DESCRIPTIVE REPORT

Registry No. **H11215**

General Locality St. Johns River

Sub-locality Venetia to Plummers Cove

Catwalk to Charter platforms a.pdf ✓

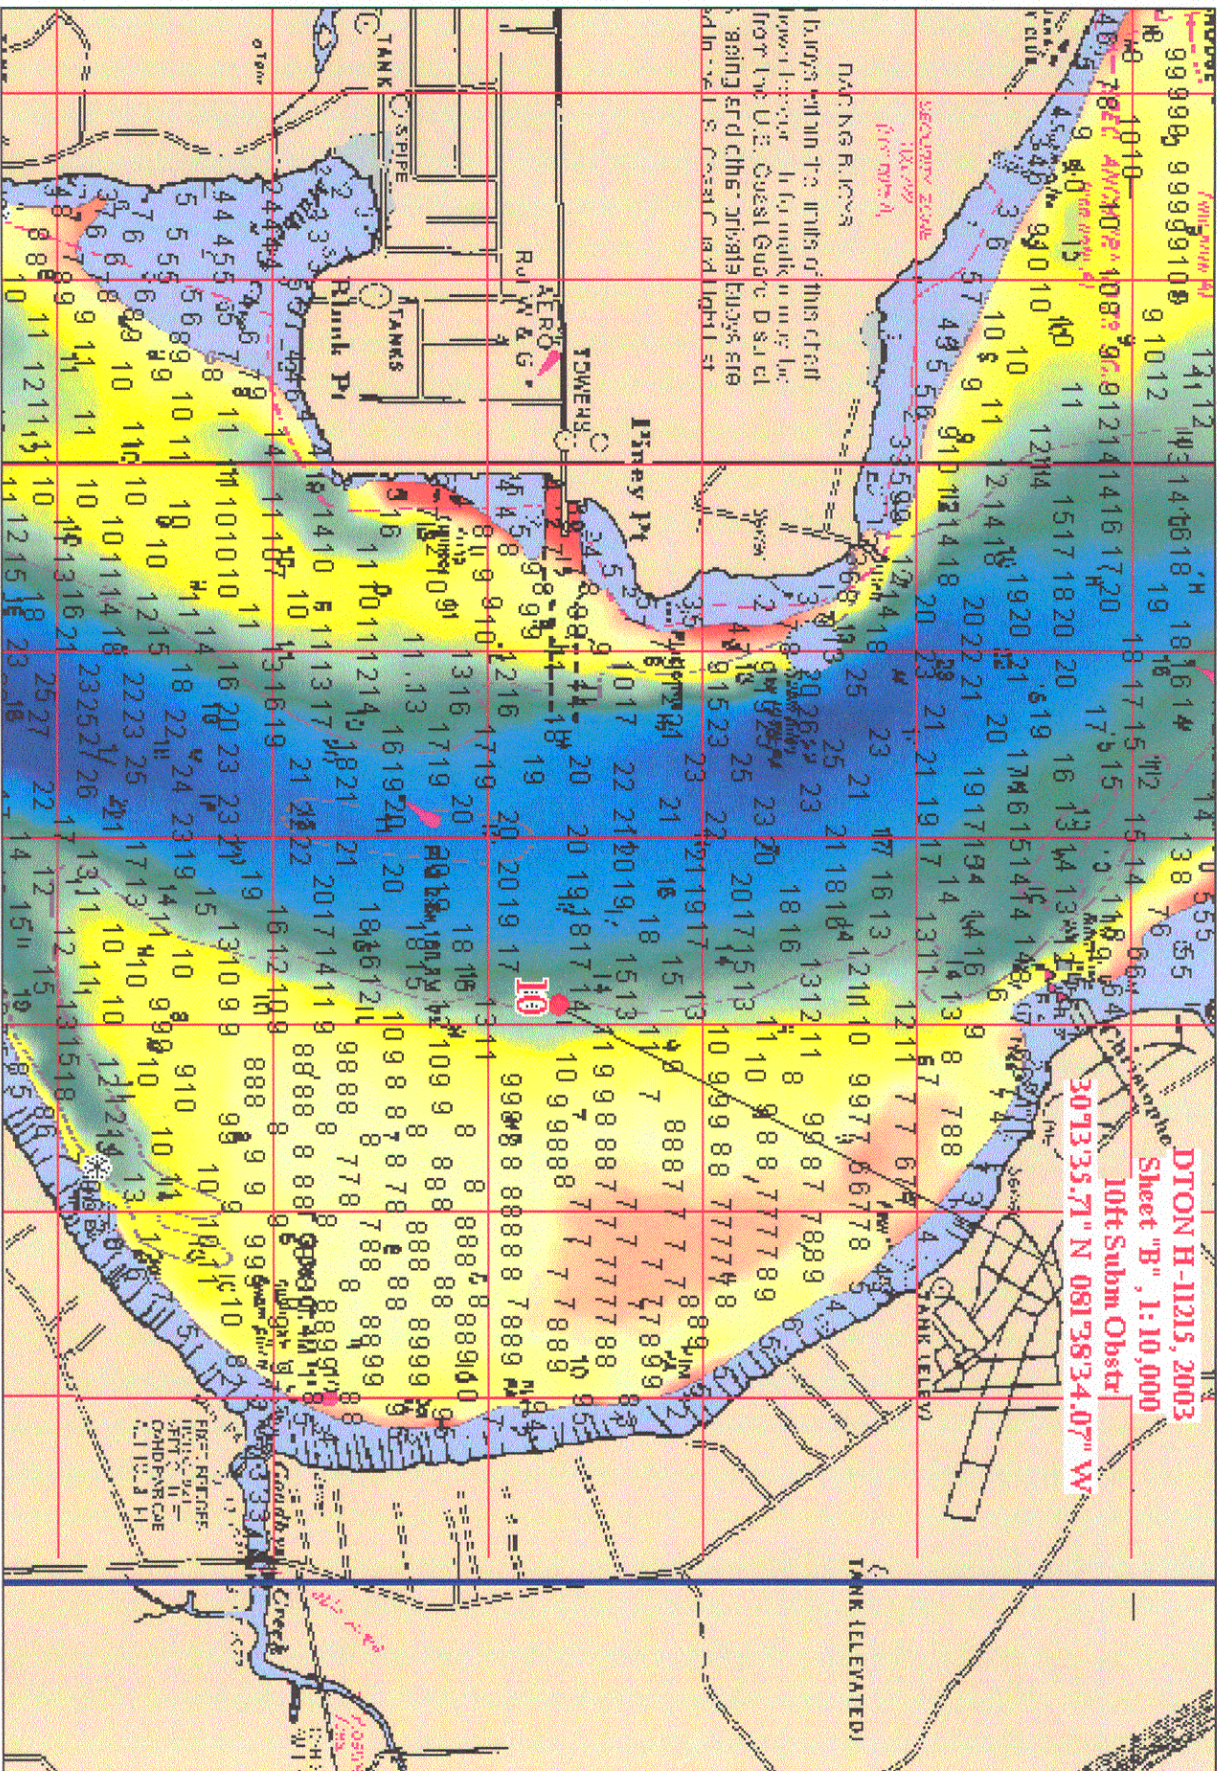
- 1.) The platforms at 30° 13' 55.39" N, 081° 39' 34.92" W, have been connected to shore with a catwalk. See photo under supplemental correspondence. ***(attached to this report) Concur, retain platforms as charted. Defer to MCD Update Service Branch for additional revision of shoreline.***

Chartlet 1 of 1 6 ft Obstruction in depths of 9 and 10 feet Lat. 30-12-59.89 N Lon. 81-39-42.23 W

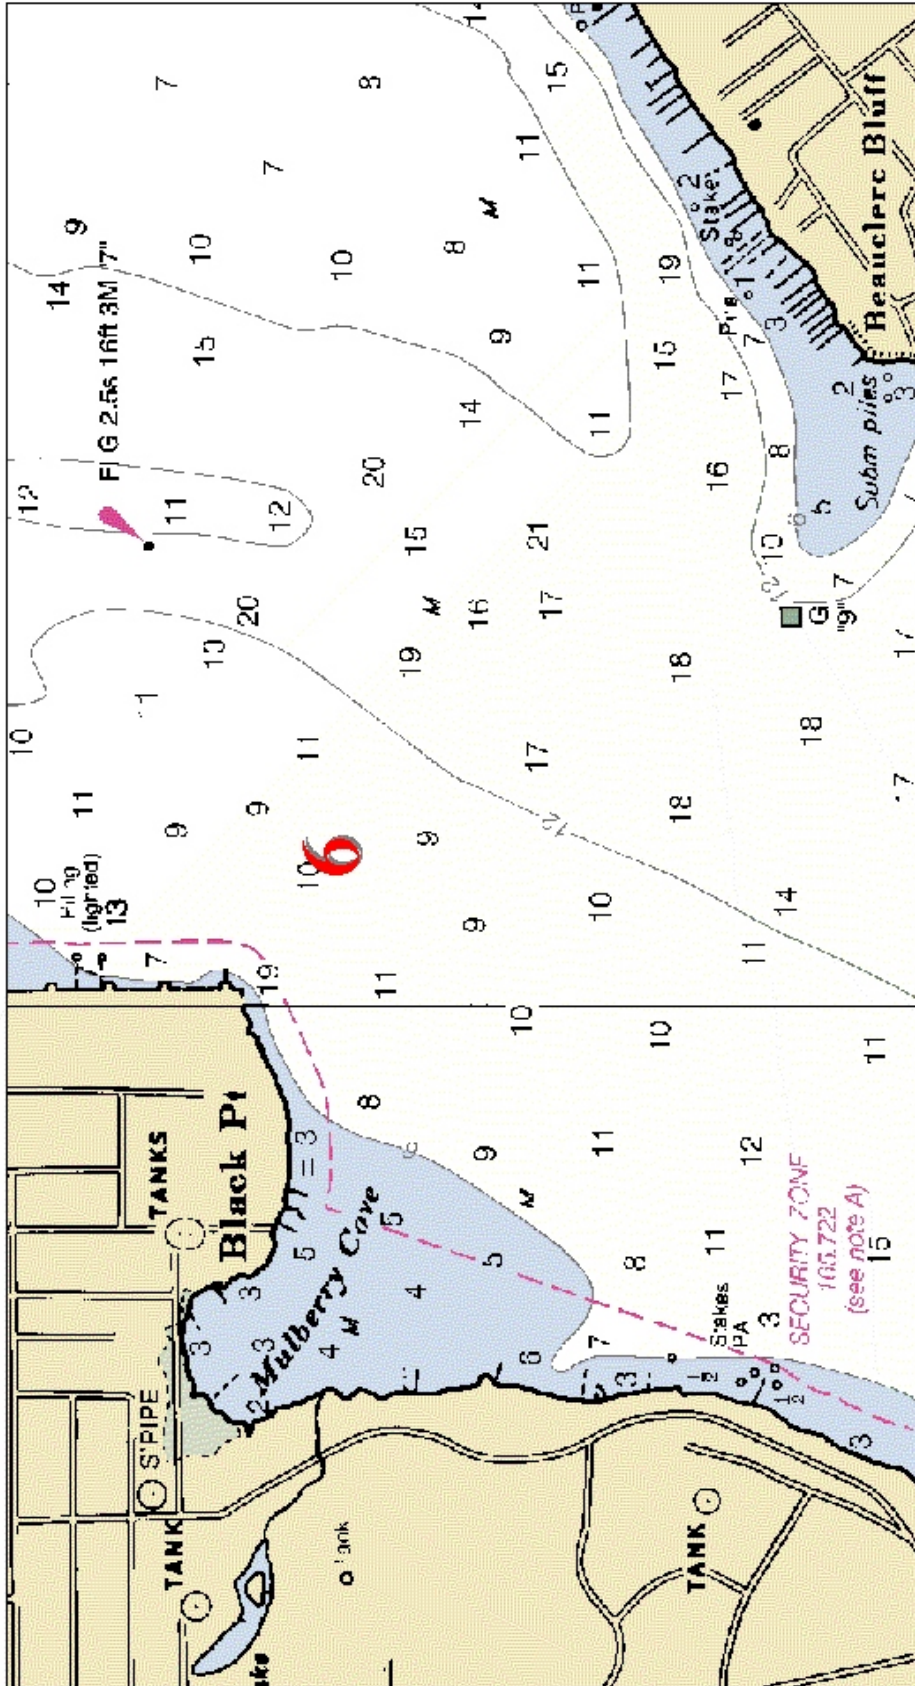
2. During office processing, a second Danger to Navigation Report was submitted to the Marine Chart Division, N/CS3x1 Silver Spring, Maryland. The item is an obstruction with a depth of 6 feet in Latitude 30°12'59.89"N, Longitude 81°39'42.23"W. It is recommended that a dangerous obstruction with a depth of 6 feet be charted. A copy of this report is appended to this report.
